<b>Company</b>	Trenz Electronic GmbH
<b>PCN Number</b>	PCN-20230619
<b>Title</b>	TE0726-03 to TE0726-04 Hardware Revision Change
<b>Subject</b>	Hardware Revision Change
<b>Issue Date</b>	2023-10-04

This change affects all Trenz Electronic TE0726 SoMs: TE0726-03\*.

## 2.21 #21 Added legal notices, revision history, block and power diagram. Updated page count and order.

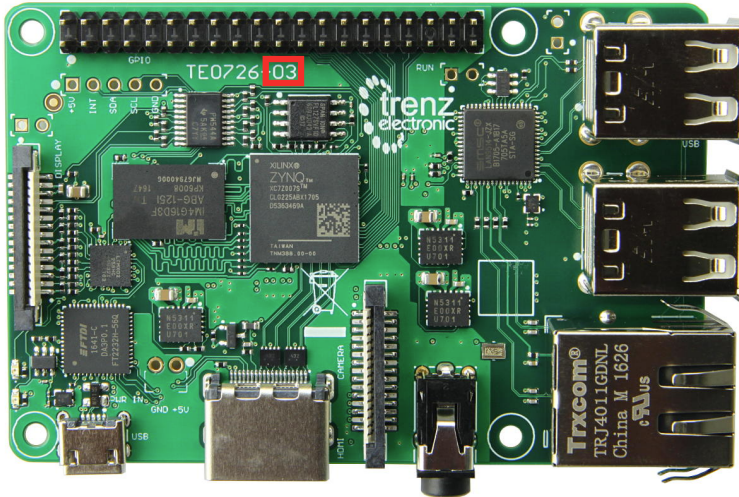
**Type:** Documentation Update

**Reason:** Documentation improvement.

**Impact:** None.
